Memo – NZTA

Subject:– Delmore Stage 1 and 2- Response to Regional NZTA Memo (Annexure 31 to Council family comments)

Stormwater comments: Peter Mitchell

Figure 1- Velocities around culvert inlet in 2 year peak (including Climate Change)

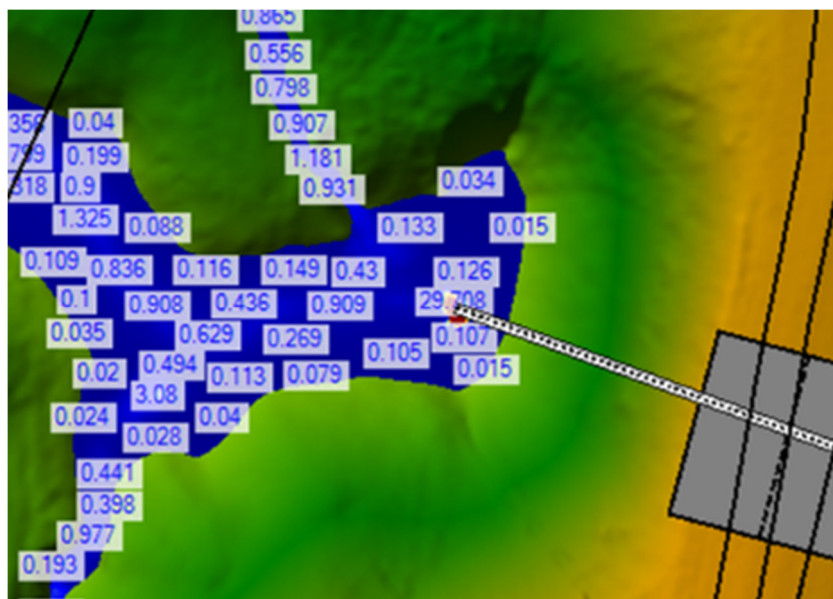
<p>It is anticipated that as a minimum this inlet will need a culvert relief inlet riser as well as erosion and scour protection/resilience measures at the highway embankment at the culvert inlet (to a height above the 1% AEP flood level - including climate change 3.8 percent)</p>

Our hydraulic modelling confirms that, despite the higher water level, flow velocities of less than 0.2m/s immediately upstream of—and around—the inlet remain well below the critical velocities of 1 to 2m/s for erosion and scour, as demonstrated in the paragraph below.

Below is a plot of the 2 year and 10 year events, from the 2D flood model including climate change. This shows the predicted velocities around the culvert inlet. In both scenarios, the flow velocities are very low, and below the velocities that cause erosion in different unlined channel materials, outlined in Auckland Councils Hydraulic Energy Management: Inlet and Outlet Design for Treatment Devices - TR2013/018. This includes the channel material relevant to the culvert NZTA is concerned about, which is highlighted yellow is the snip of Table 1 from TR2013/018 in Figure 3 below, or if the grass cover is considered, then the values in green are of relevance.

Overall, this analysis shows in the Post Development risk of erosion around the inlet is very low, so provision of rip-rap protection (i.e. erosion and scour protection) is not considered to have any benefit.
